PLANNING COMMISSION AGENDA

Conditional Use Permit No. 2017-22: A request by ARCO AM/PM to construct a new ARCO AM/PM gas station consisting of a 6,500 square foot convenience store building, a 3,850 square foot automated carwash building, and a 6,800 square foot fuel canopy with 10 fuel dispensers. The Cameron Creek ARCO AM/PM is part of the Cameron Creek Shopping Center and zoned C-MU (Commercial Mixed Use). The parcel for the proposed ARCO AM/PM gas station is located on the southeast corner of West Caldwell Avenue and South West Street (APN: 126-870-037). A Mitigated Negative Declaration (MND No. 2017-39) has been prepared for the project.

REPORT TO CITY OF VISALIA PLANNING COMMISSION

Signage for ARCO AM/PM

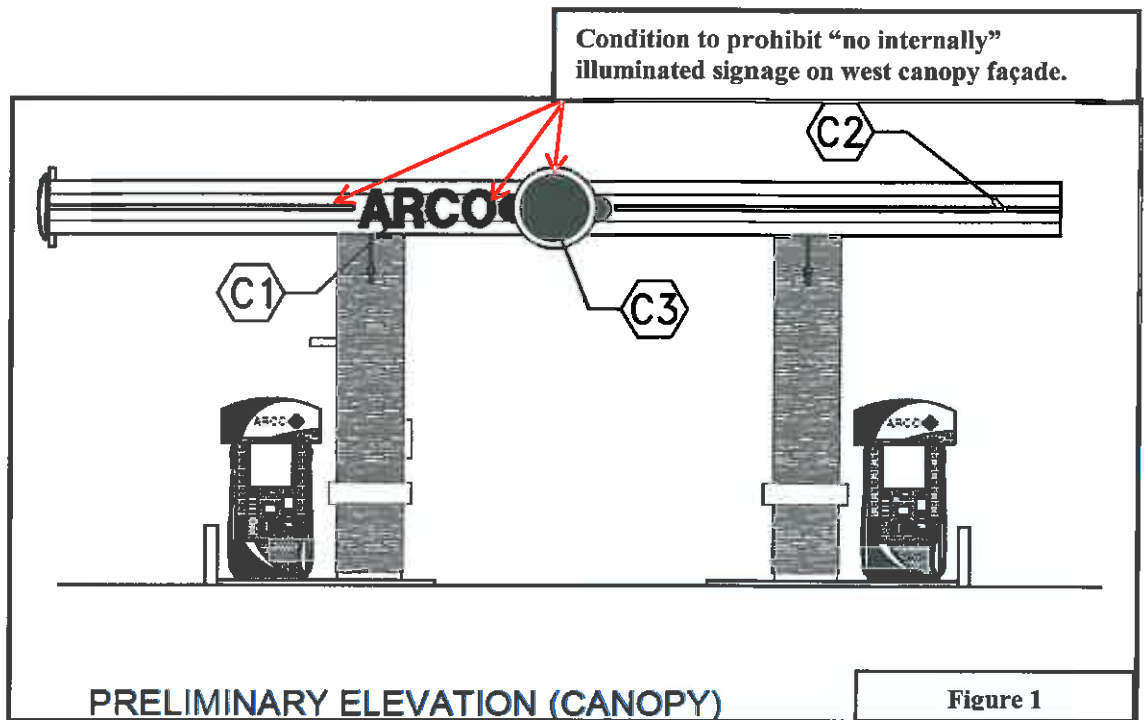
The applicant has provided Exhibit "D" depicting the proposed signage for the ARCO AM/PM site. Exhibit "D" identifies the location and wall placement of each sign as well as the sign areas for wall/canopy signage and the monument sign. The thematic signage is consistent with signage proposed on other ARCO AM/PM gas stations developed in Visalia over the past three years.

Wall signage for both the convenience store and the canopy signage are within the allowable sign area for a commercial development. The monument sign height is within the allowable sign height for freestanding monument signs; however, the monument sign area exceeds the maximum 35-square feet per sign face. The monument sign, as depicted on Exhibit "D" identifies a sign face area of 46-square feet. Staff has included Condition No. 4 requiring the monument sign area be approved at 35-square feet and located 5-feet from property lines, which is consistent with Section 17.48.110.C.4 and 5 of the Sign Ordinance for freestanding monument signs.

4. That the ARCO AM/PM sign program comply with the sign areas as depicted on Exhibit "D" subject to the freestanding monument sign area be revised to comply with the 35-square foot sign area as required pursuant to Section 17.48.110.C.4 of the Sign Ordinance

Illuminated Signage on Gas Station Canopy – Impacts to Residential

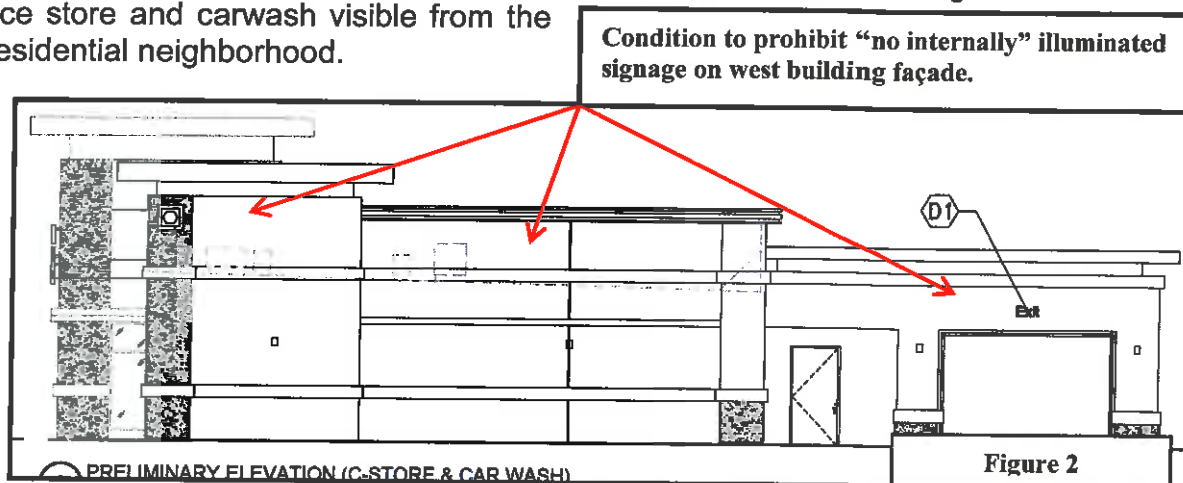
In addition, Condition No. 13 requires that there shall be no internally illuminated signage on the west exterior fascia of the canopy including any type of light strips or LED/neon banding (see Figure 1). The elimination of canopy lighting along the west exterior of the canopy is due to the fact that the canopy signage is approximately 16 to 18 feet in height, and could be clearly visible from residences over the block wall west of West Street. The sign exhibit submitted and attached as Exhibit "D" currently shows use of a lighted decal/spark and band on the canopy elevations.

Condition No. 14 is also included to address illuminated building signage near the top of the west building façade for the ARCO AM/PM convenience store and carwash building that may be clearly visible from adjacent residential properties to the west. Condition No. 14 states that illuminated building signage shall be prohibited along the west building facades for the convenience store and carwash visible from the adjacent residential neighborhood.

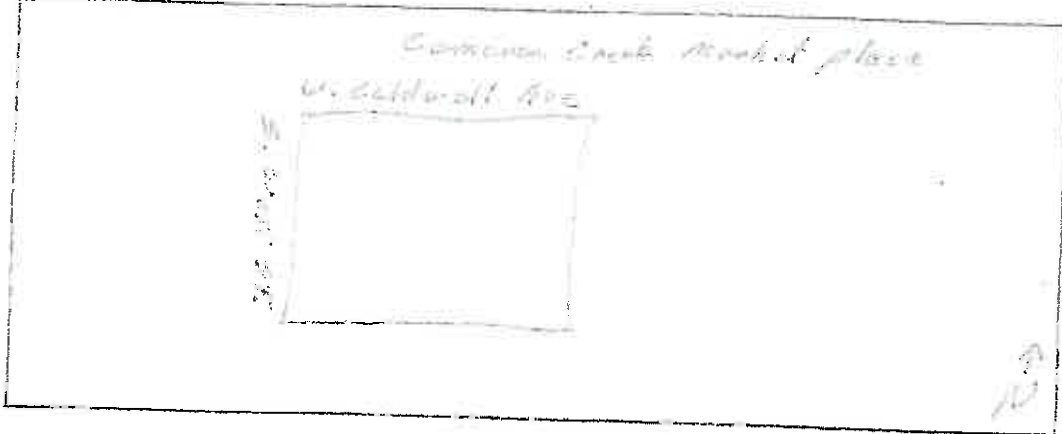
Special comments: MEET THE NVELO REQUIREMENTS FOR THE
NEW LANDSCAPING. PROVIDE GREEN
INTERCEPTOR.
